_	Case No.:	
Fee: \$750.00	MAR 2 8 2023	Date File	l:
	Zoning Board of Ap Village/Town of Mount		
	Village/Town of Mo		
	Municipal Buil		
	104 Main Street, Mt. Kiso	co, NY 10549	
	Zoning Board of A		
	Application	1	
Appellant: DP 21, LLC			
	ford Road, Suite 145, Moun		
Address of subject proper	rty (if different): 333 Nor	rth Bedford Road, M	ount Kisco, NY 1054
Appellant's relationship t	to subject property: X	Owner Les	ssee Other
Property owner (if different Address:	ent): Same as above		
	ZONING BOARD OF AP Building Inspector, <b>Peter</b>		
dated 09/06/2019	. Application is hereby	made for the follow	ving:

WITHIN 1,470± SF TELECOMMUNICATIONS

SITE 180 S. BEDFORD RD. ADDRESS: MT. KISCO, NY 10594

COMPOUND PLAN

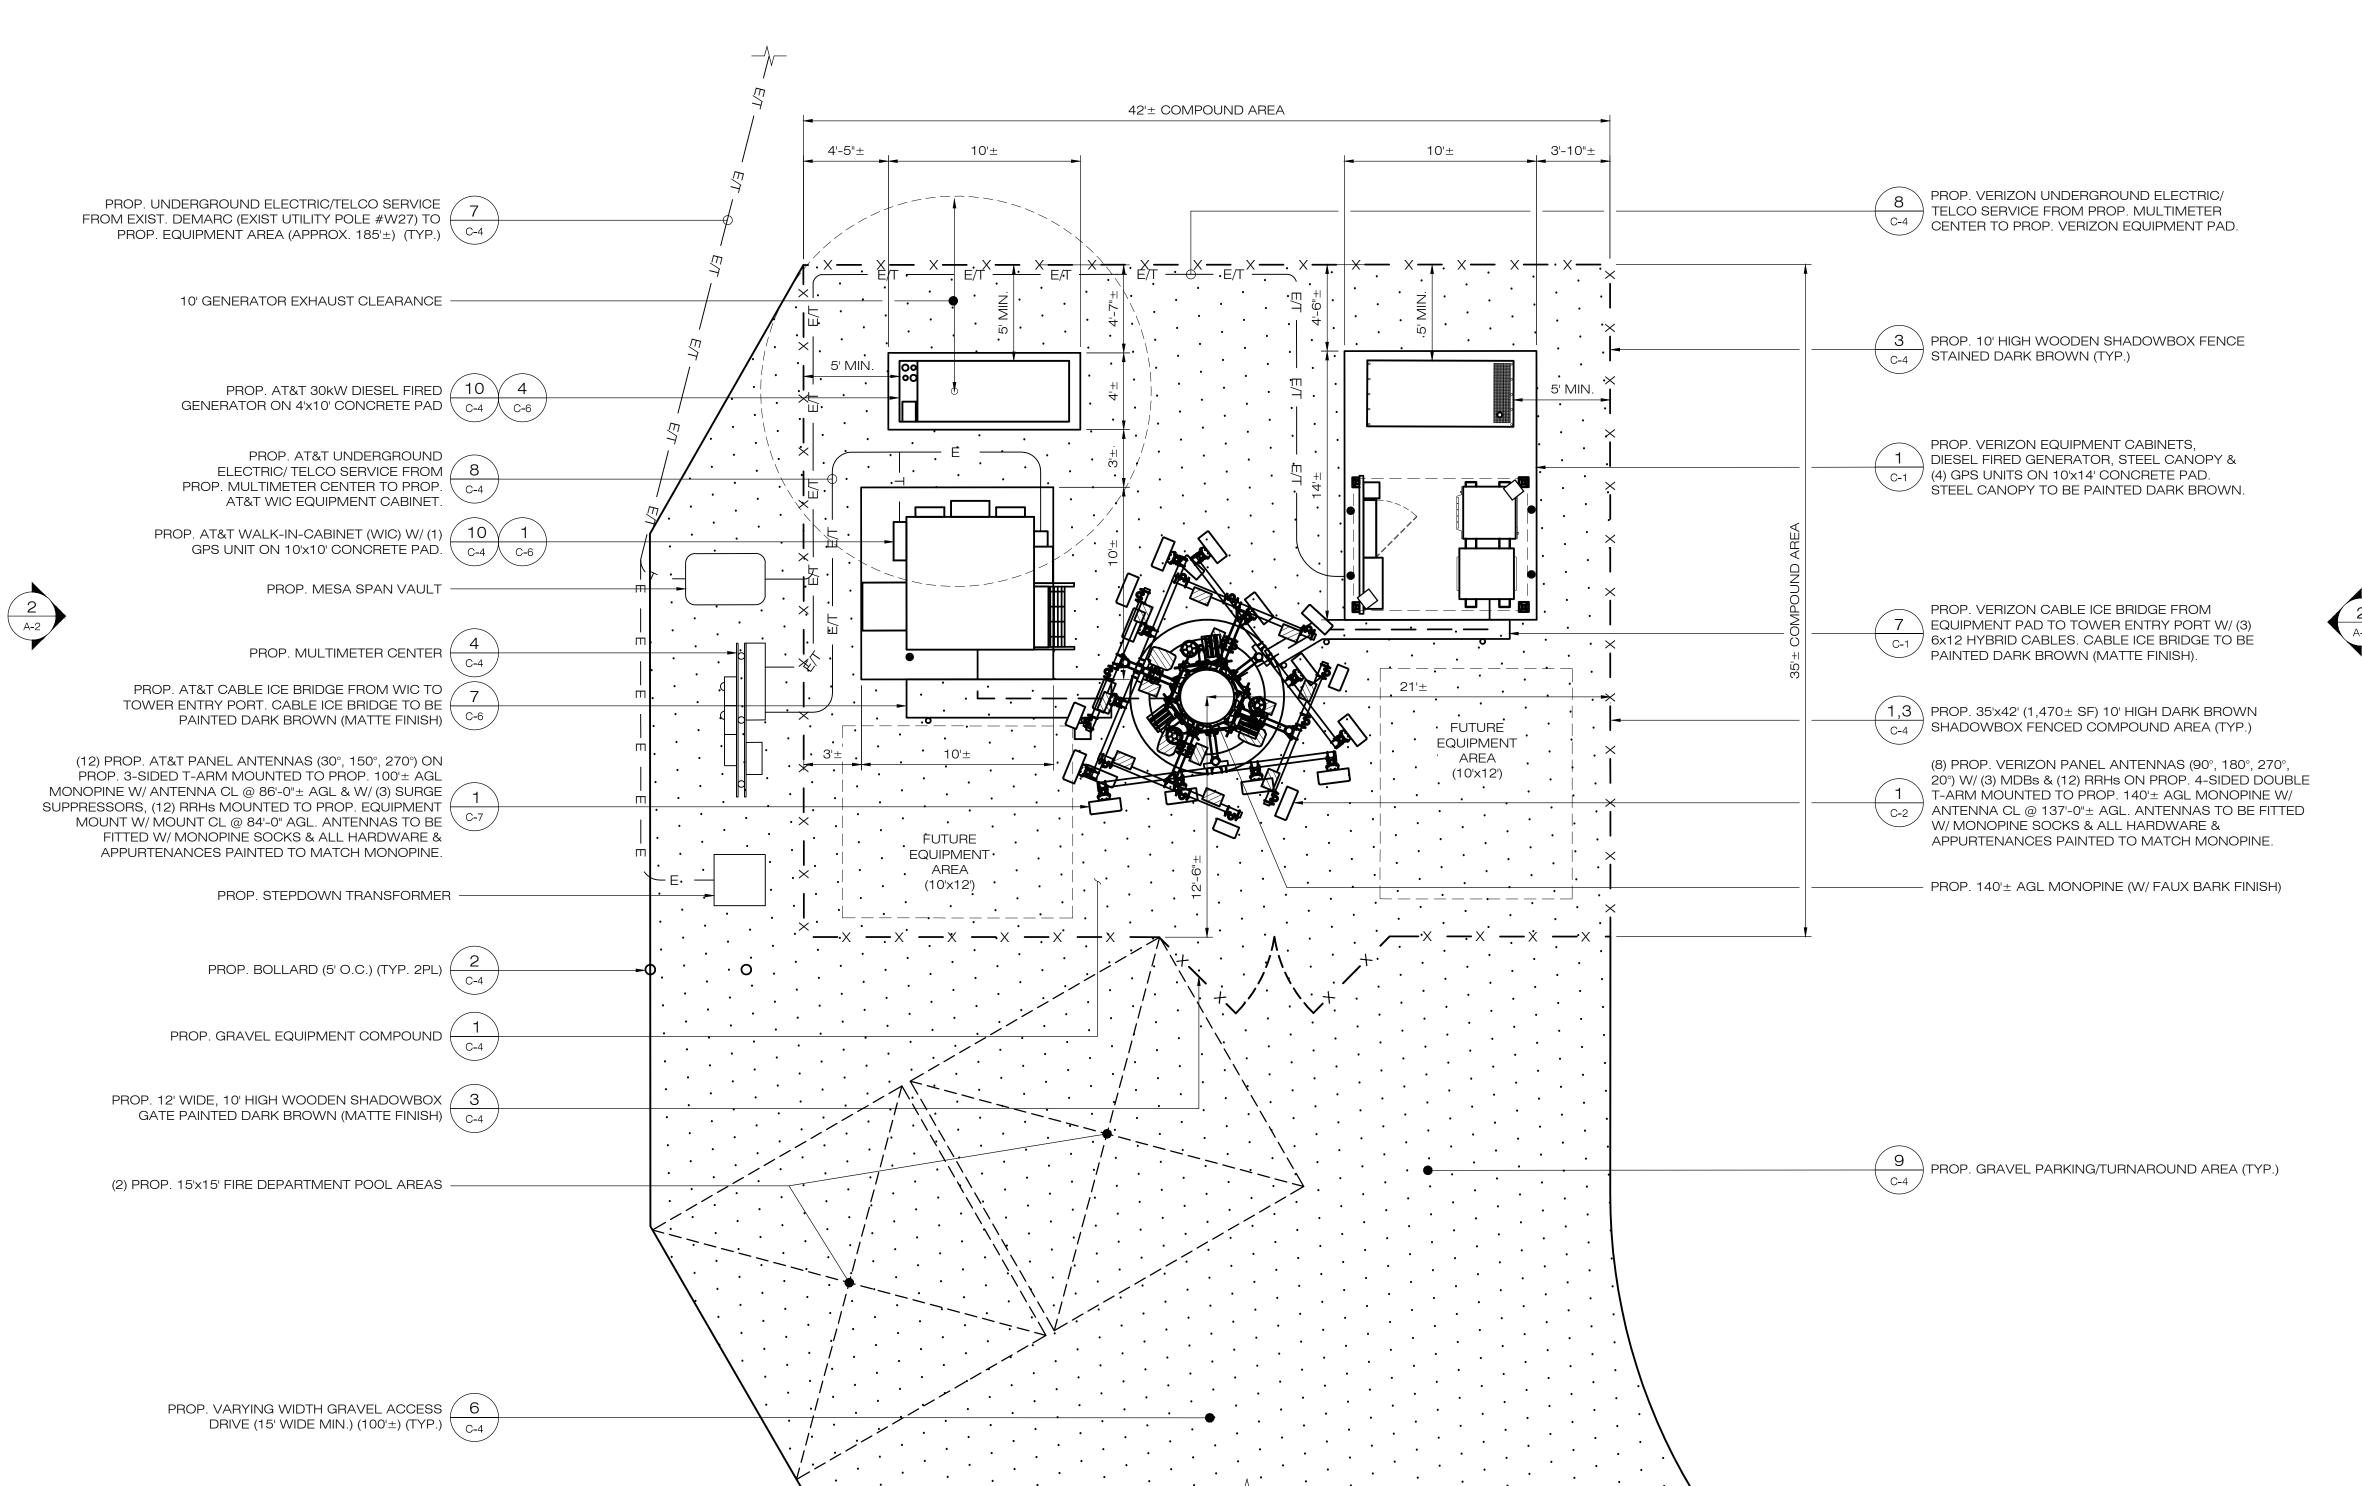
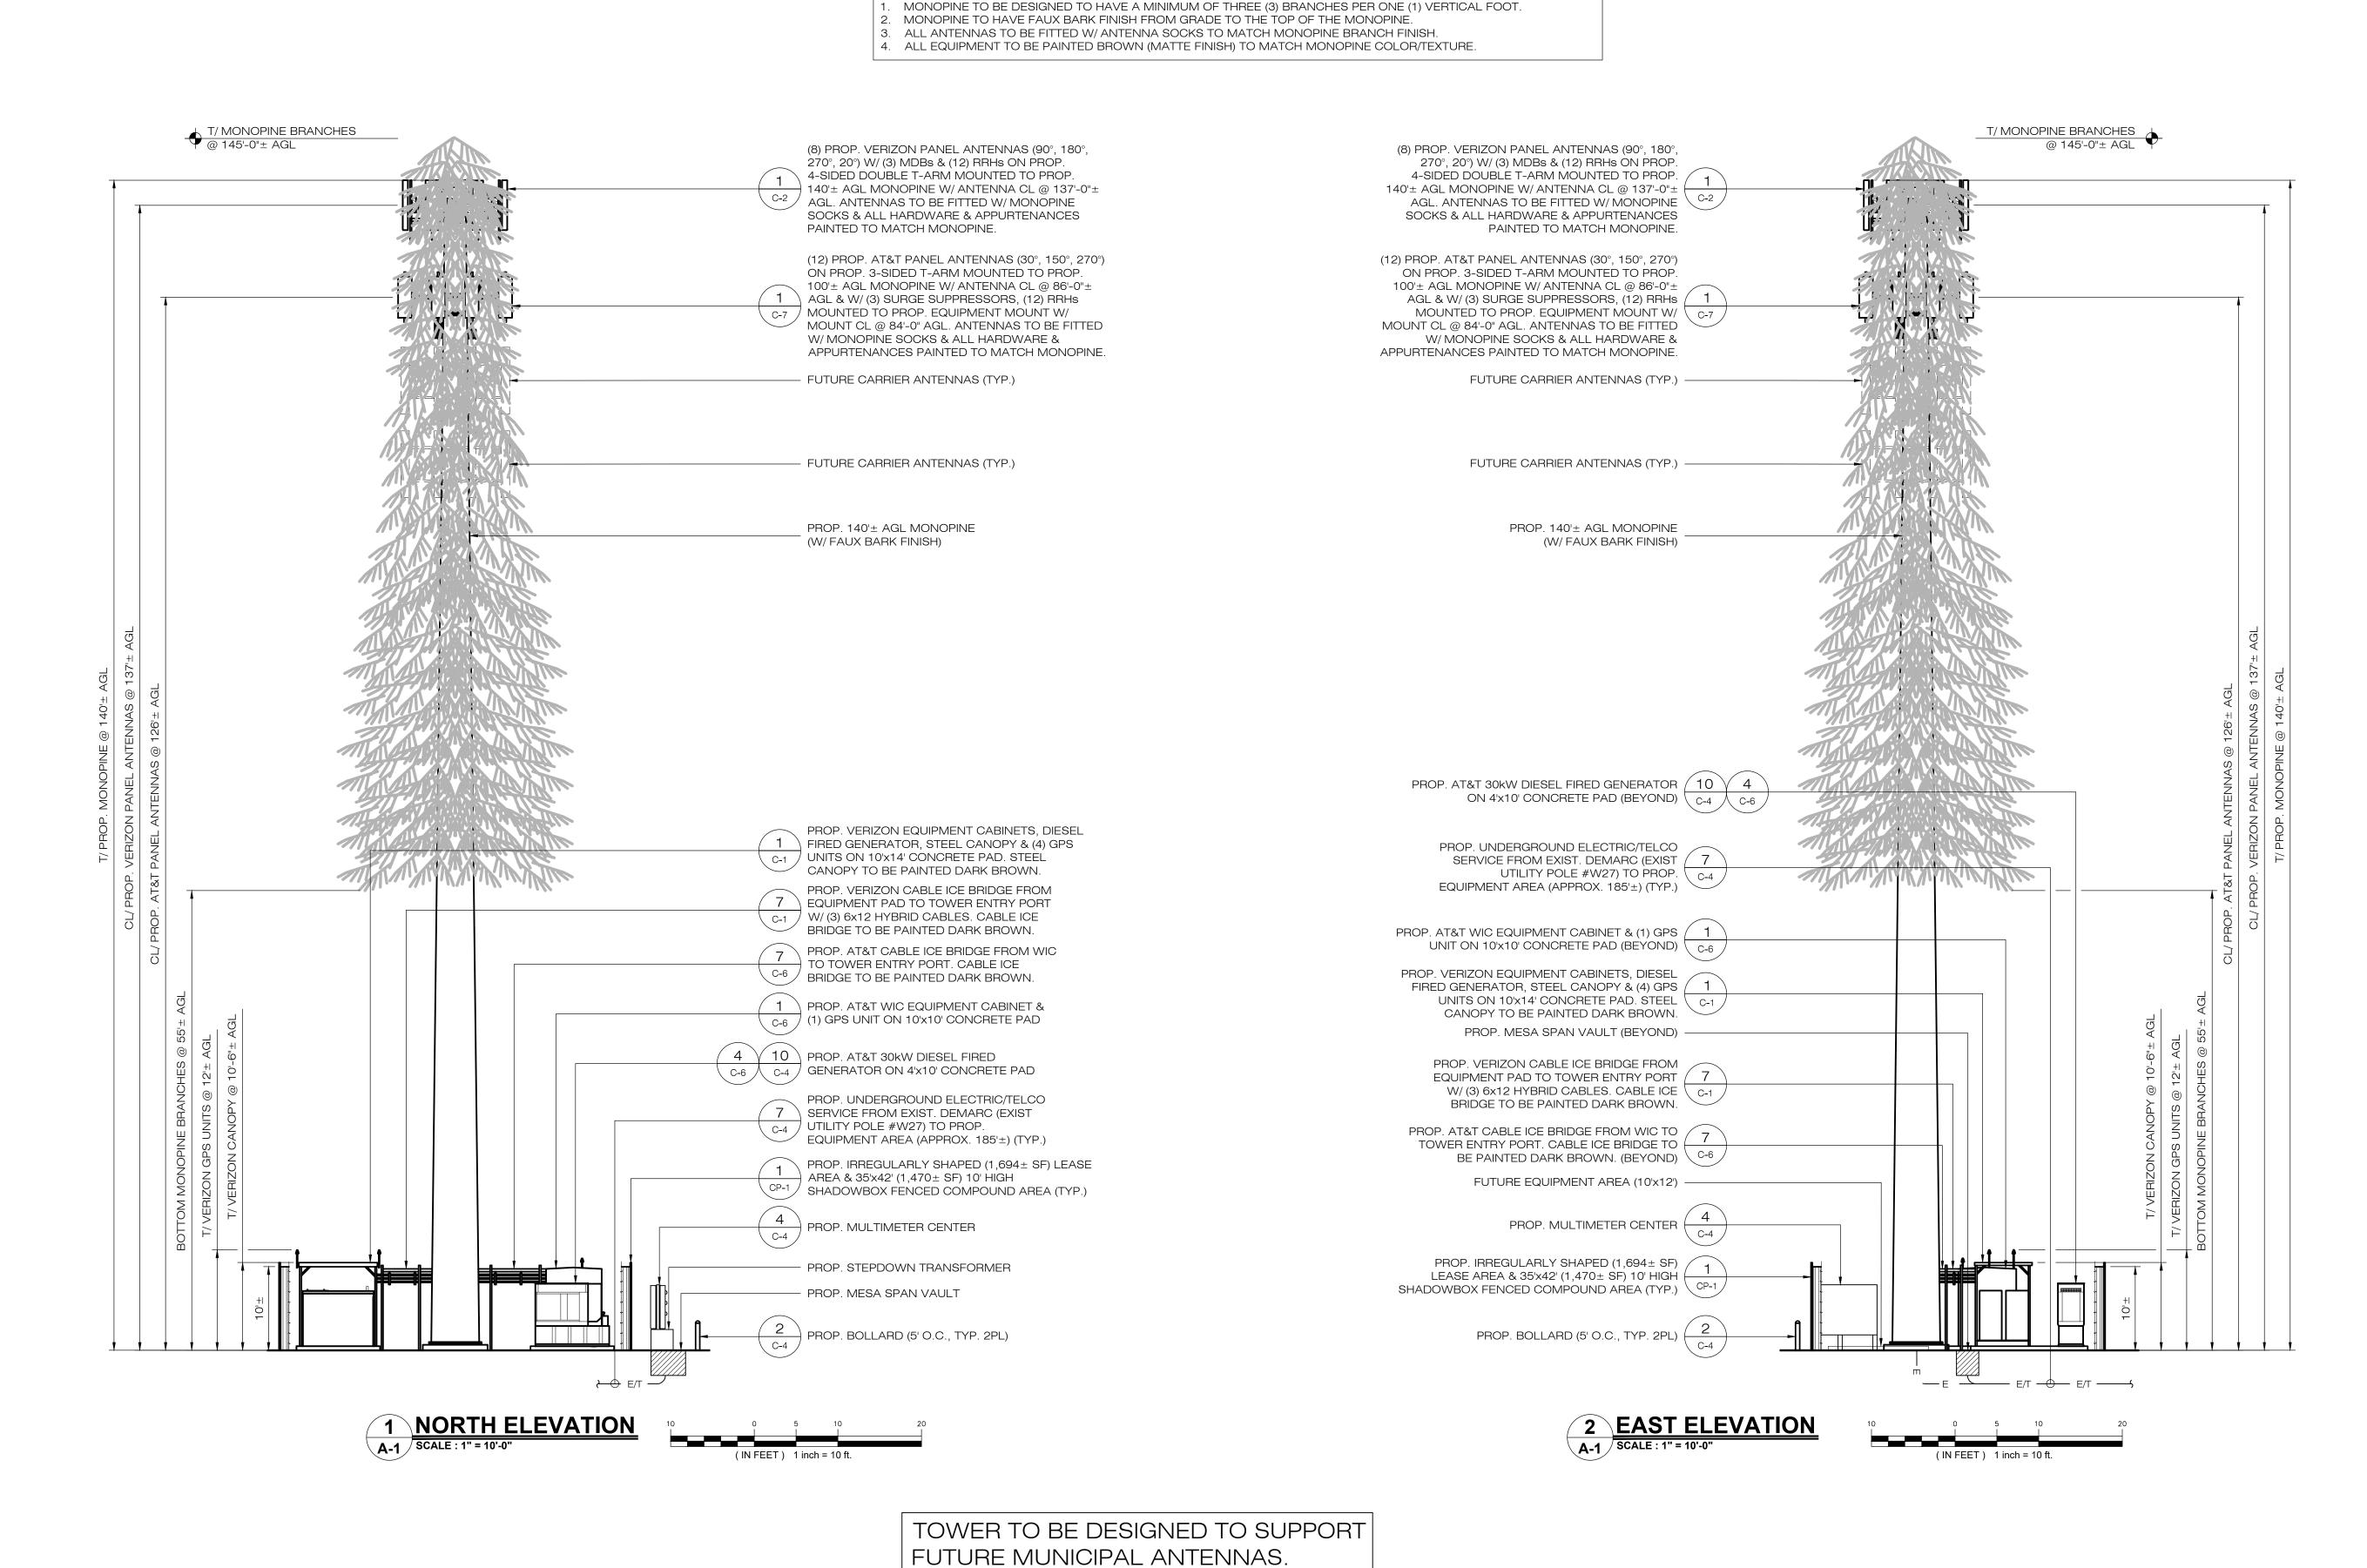
- O GENERATORS two emergency back-up generators are shown on the Site Plan Drawings (sheets CP-1, C-1, and the elevation views). Verizon proposes a 50-kW propane generator with 500-gallon tank, and AT&T (interested co-locator) proposed a 30-kW diesel generator with intrinsic fuel storage. A future Planning Board resolution may prescribe the frequency and times that the generators are to be tested / cycled (e.g., typically 1 time per month, on a weekday during business hours, for a run period not to exceed 20 minutes). HDR notes that the generators are not run on a daily or continuous basis when back-up power is not needed.
- o FIRE PROTECTION. Recent discussions with the Building Inspector and a Fire Department representative clarified that the two 15 ft x 15 ft pool areas should be retained on the south side of the equipment compound, considering the "one project" assumption.

A note regarding the scheduling of the generator testing/cycling has been added to Drawings CP-1, C-1 and C-6.
- Include note for compound lighting, to the affect: Two 52-watt switch/timer controlled light fixtures are proposed at the ground-based equipment compound for nighttime visits (the lights are only used when needed by a service technician). This lighting can be specified to comply with guidance from the International Dark Sky Association (IDA: Outdoor Lighting Basics International Dark-Sky Association). Motion detection lighting shall not be installed. No tower lighting is required or proposed for the project.
  - Notes have been added to Drawings C-3 and C-6 addressing the individual carrier equipment area lighting.
- Add location of fire extinguishers to canopy / equipment cabinet areas.
   (2) fire extinguishers have been added to the drawings (see Drawings C-1 and C-6).
